PERMIT DOCUMENTS FOR TRAIL RIDGE LANDFILL FIRST RAI RESPONSE

Reference Trail Ridge Landfill - Second Permit Renewal
FDEP Permit No 0013493-001 and 0013493-002
FDEP File Numbers 13493-010 and 13493-011
ET&M No E02-25-3

We have received your letter dated October 25, 2002 regarding the referenced project. On behalf of Trail Ridge Landfill, Inc, please find the following response to your request for additional information

Attachment 1, Review Memorandum, dated October 25, 2002, prepared by Julia Boesch

DRAWING TITLE: (6) LEACHATE STORAGE TANK
 14" DIA NOM. x 18'-0"

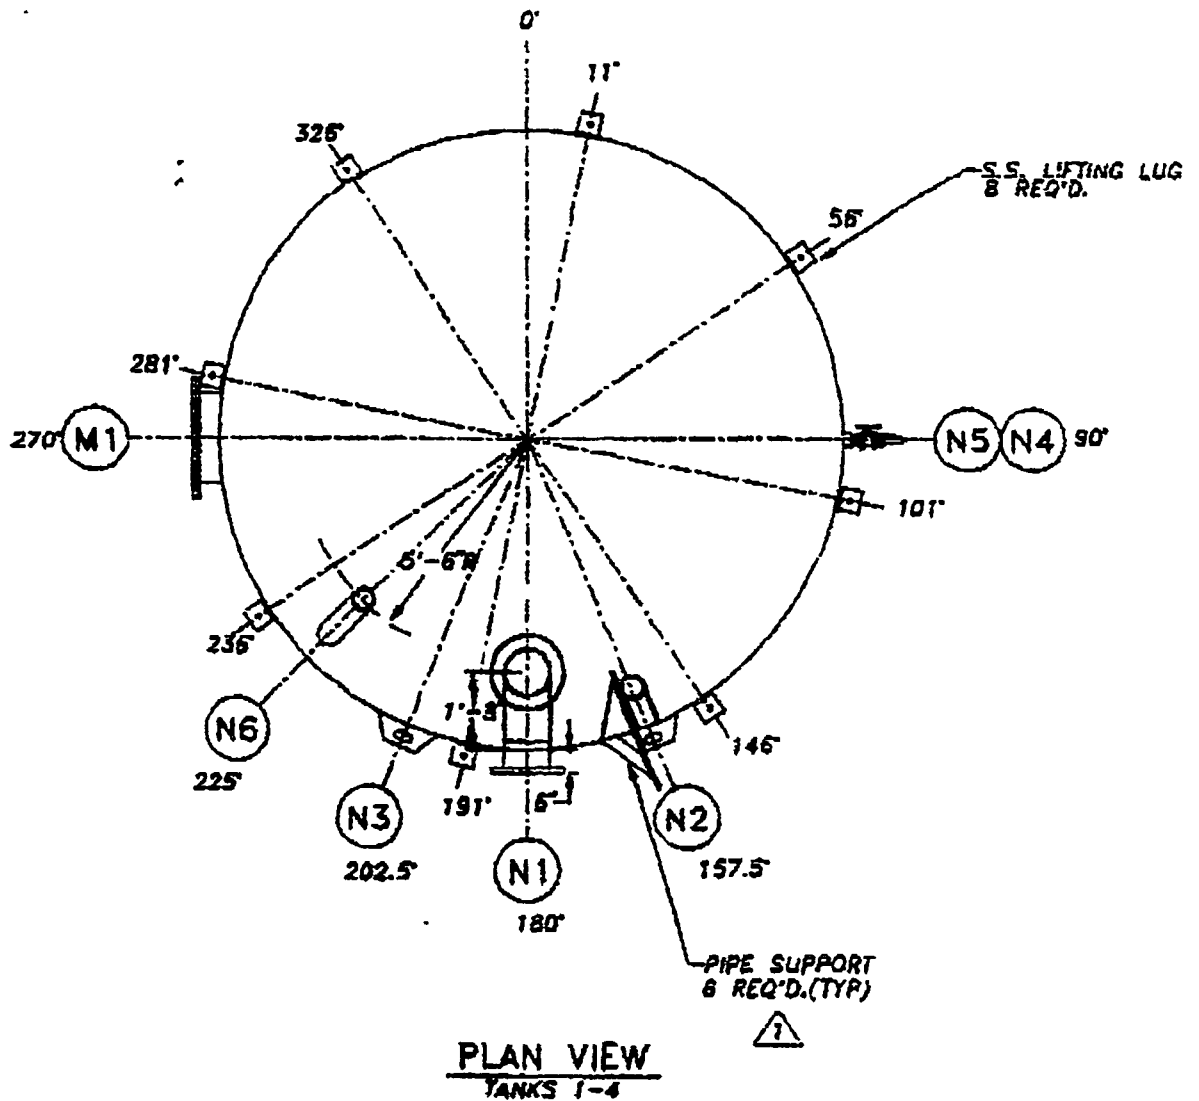
<input type="checkbox"/> NO EXCEPTION TAKEN	<input checked="" type="checkbox"/> MAKE CORRECTIONS
<input type="checkbox"/> REJECTED	<input type="checkbox"/> REVISE AND RESUBMIT
<input type="checkbox"/> SUBMIT SPECIFIED ITEM

- (1) Install guard over sample valve
- (2) Inspect dryer/tank vent yearly
- (3) The maximum interval, until the next external inspection would be three years, due to State and County regulations
- (4) Based on the extent of the inspections performed on tank # 01,
The test results show no substantial corrosion above and beyond
That noted as of the test date (Sept.21,01) This is not to be constructed
as an expressed or implied warranty of future performance

DRAWING TITLE: (6) LEACHATE STORAGE TANK
14" DIA NOM. x 18'-0"

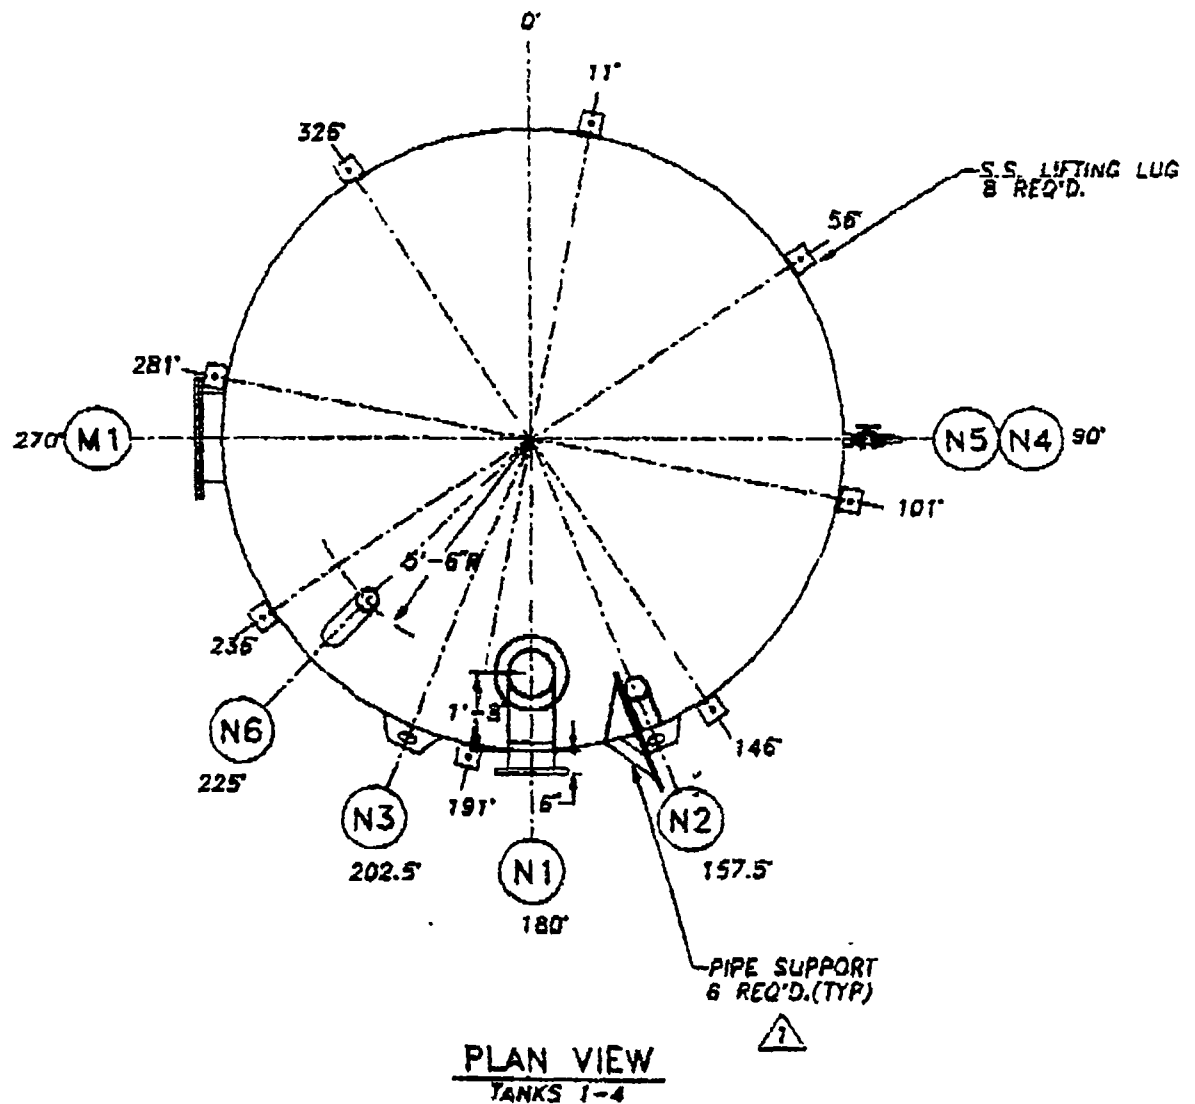
<input type="checkbox"/> NO EXCEPTION TAKEN	<input checked="" type="checkbox"/> MAKE CORRECTIONS
<input type="checkbox"/> REJECTED	<input type="checkbox"/> REVISE AND
<input type="checkbox"/> SUBMIT SPECIFIED	<input type="checkbox"/> RESUBMIT
ITEM

- (1) Install guard over sample valve
- (2) Remove and replace brass ball valve on sample port. Replacement recommended to be CPVC or 304 grade stainless steel
- (3) Inspect dryer/tank vent yearly.
- (4) The maximum interval, until the next external inspection would be three years, due to State and County regulations
- (5) Based on the extent of the inspections performed on tank # 02, the test results show no substantial corrosion above and beyond that was noted as of the test date (Sept,21,01). This is not to be construed as an expressed or implied warranty of future performance.

DRAWING TITLE: (6) LEACHATE STORAGE TANK
 14" DIA NOM. x 18'-0"

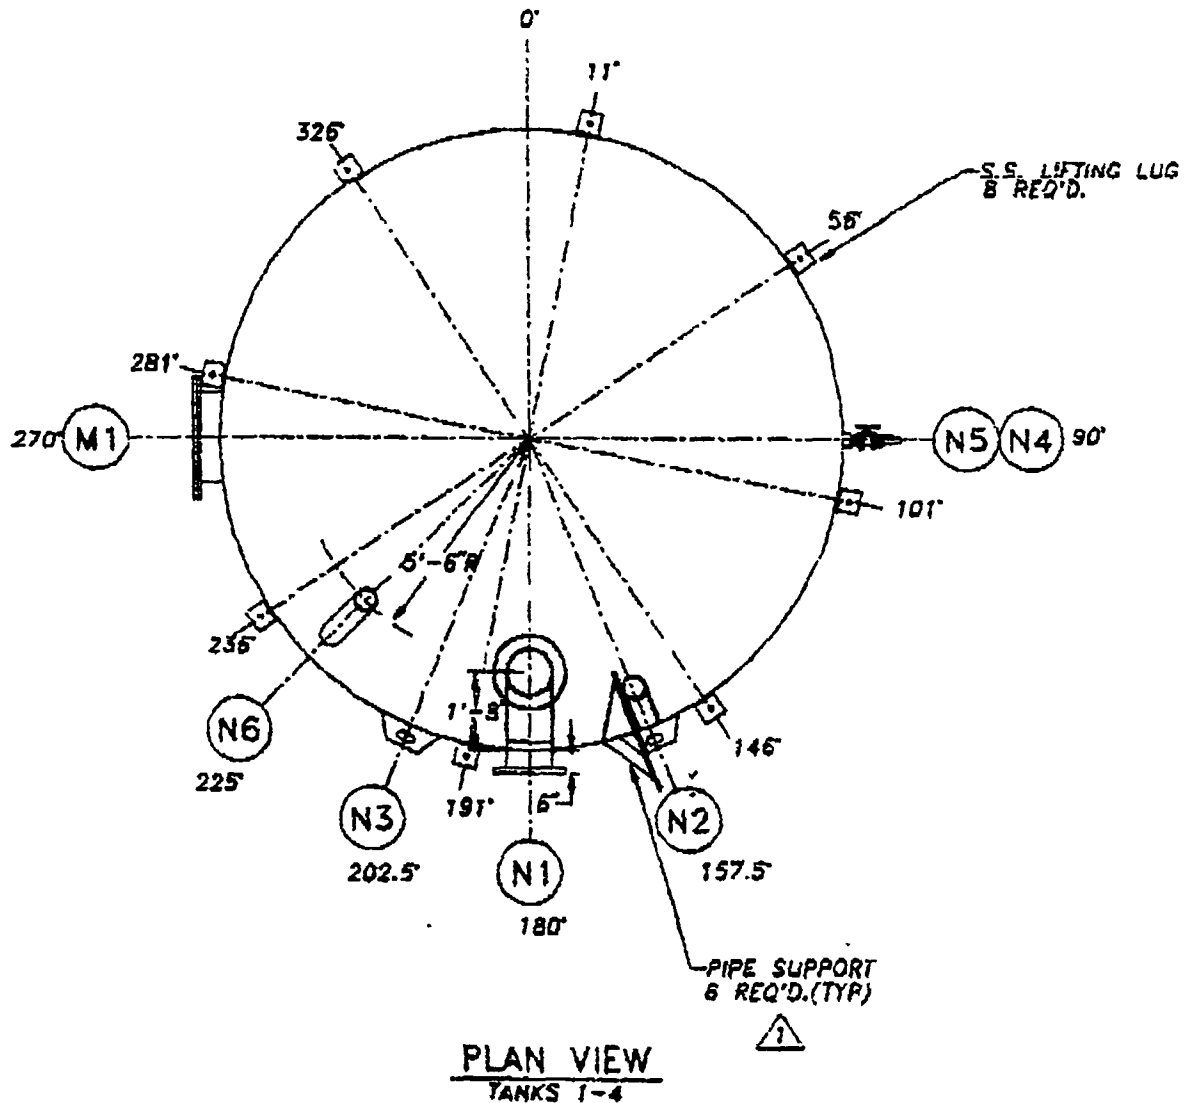
<input type="checkbox"/> NO EXCEPTION TAKEN	<input checked="" type="checkbox"/> MAKE CORRECTIONS NOTED
<input type="checkbox"/> REJECTED	<input type="checkbox"/> REVISE AND RESUBMIT
<input type="checkbox"/> SUBMIT SPECIFIED ITEM

- (1) Install guard over sample valve.
- (2) Remove and replace brass ball valve on sample port Replacement recommended to be CPVC or 304 trough 316' grade stainless steel.
- (3) Inspect dryer/tank vent yearly.
- (4) The maximum interval, until the next external inspection would be three years, due to State and County regulations.
- (5) Based on the extent of the inspections performed on tank # 03, the test results show no substantial corrosion above and beyond that was noted as of the test date (Sept,21,01) This is not to be construed as an expressed or implied warranty of future performance.

DRAWING TITLE: (B) LEACHATE STORAGE TANK
 14" DIA NOM. x 19'-0"

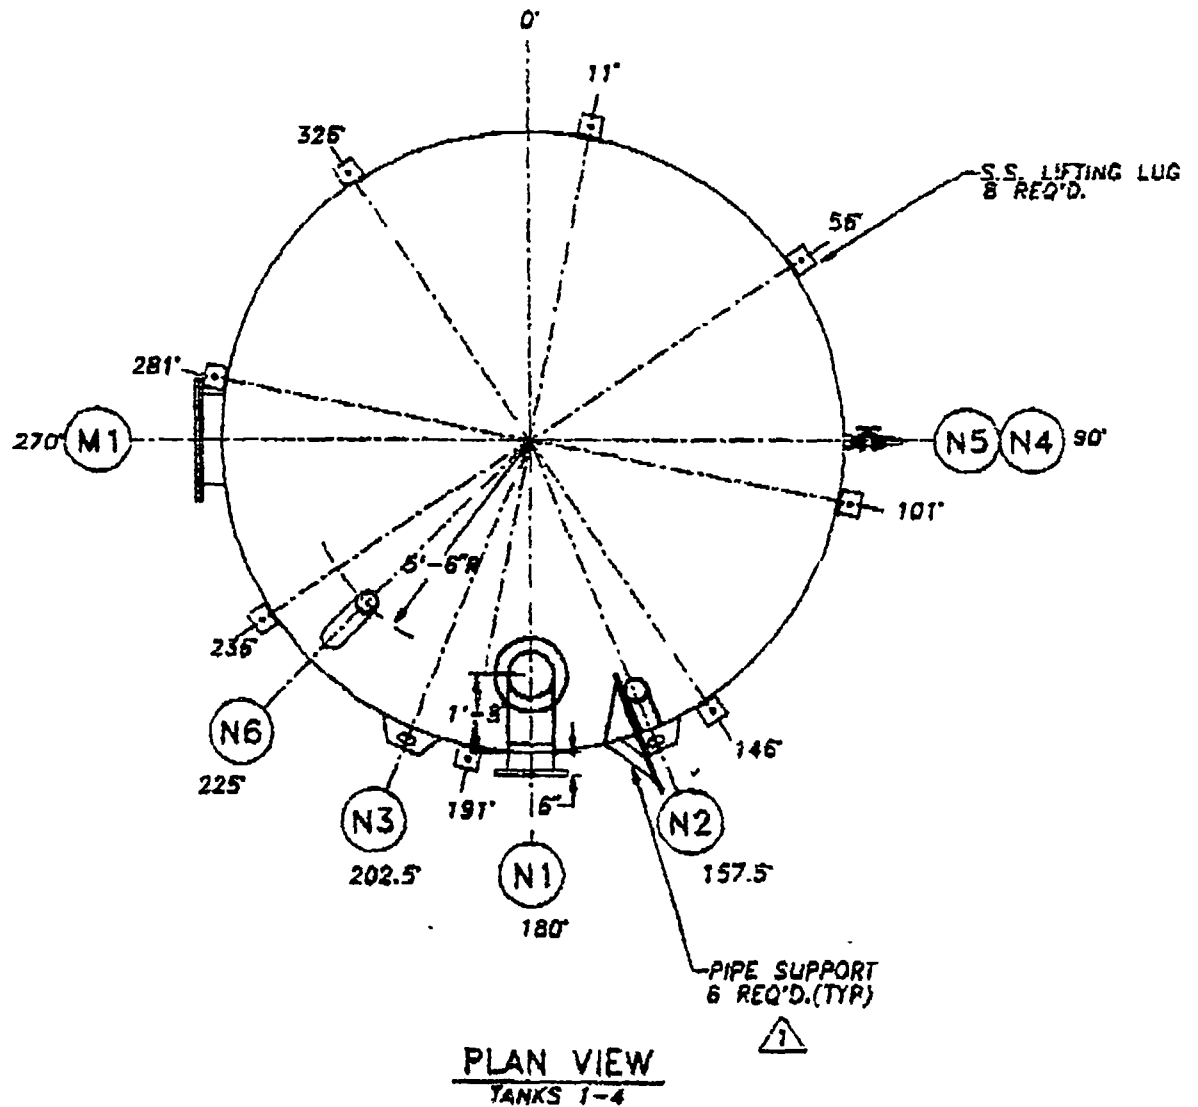
<input type="checkbox"/> NO EXCEPTION TAKEN	<input checked="" type="checkbox"/> MAKE CORRECTIONS
<input type="checkbox"/> REJECTED	<input type="checkbox"/> REVISE AND
<input type="checkbox"/> SUBMIT SPECIFIED	<input type="checkbox"/> RESUBMIT
ITEM	
<p>Checking is only for general conformance with the design concept of the project and general compliance with the information given in the contract documents. Any detail shown is subject to the requirements of the plans and specifications. Contractor is responsible for dimensions, which are to be confirmed and verified at the job site prior to construction and for the accuracy of the information of this drawing. The contractor shall be responsible for the accuracy of the information of this drawing.</p> <p>ENGLANDTHINSMILLER, INC.</p>	
Date:	2-4-92
By:	Douglas W. Hunter

- (1) Install guard over sample valve.
- (2) Inspect dryer/tank vent yearly
- (3) Repair leak on original gauging port at roof
- (4) The maximum interval, until the next external inspection would be three years, due to State and County regulations.
- (5) Based on the extent of the inspections performed on tank # 04, the test results show no substantial corrosion above and beyond that was noted as of the test date (Sept,21,01) This is not to be construed as an expressed or implied warranty of future performance.

DRAWING TITLE: (6) LEACHATE STORAGE TANK 14' DIA NOM. x 19'-0"	PROJECT NAME: TRAIL RIDGE LANDFILL
DESCRIPTION: ELEVATION VIEW	PREPARED FOR: JAX UTILITIES
PURCHASE ORDER: 58830	DRAWING NUMBER: 90-1074-01

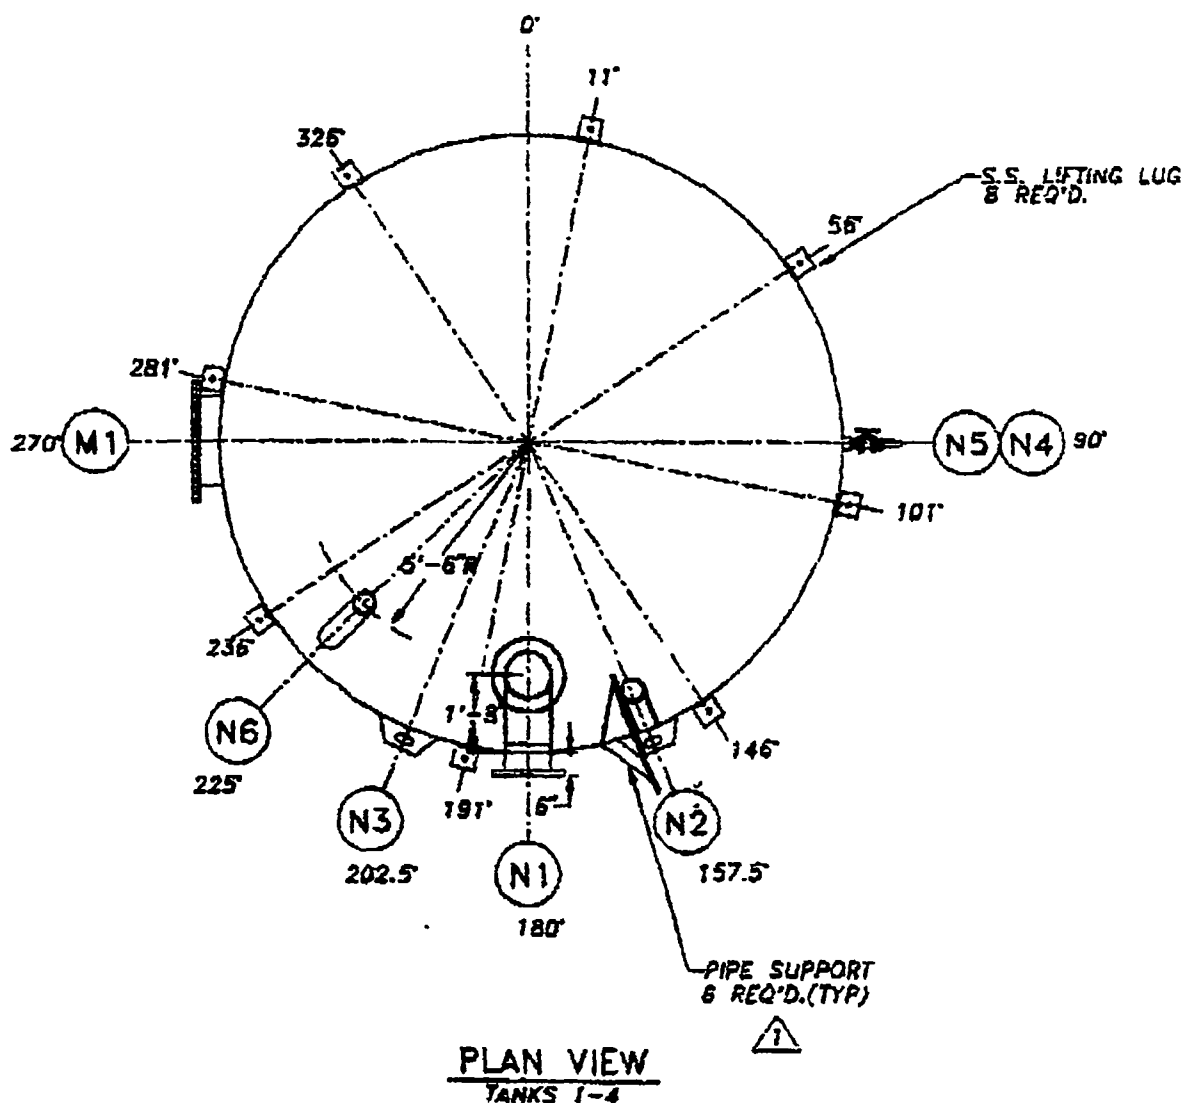
<input type="checkbox"/> NO EXCEPTION TAKEN	<input checked="" type="checkbox"/> MAKE CORRECTIONS NOTED
<input type="checkbox"/> REJECTED	<input type="checkbox"/> REVISE AND RESUBMIT
<input type="checkbox"/> SUBMIT SPECIFIED ITEM

- (1) Install guard over sample valve.
- (2) Inspect dryer/tank vent yearly.
- (3) The maximum interval, until the next external inspection would be three years, due to State and County regulations.
- (4) Based on the extent of the inspections performed on tank # 05, the test results show no substantial corrosion above and beyond that was noted as of the test date (Sept,21,01). This is not to be construed as an expressed or implied warranty of future performance.
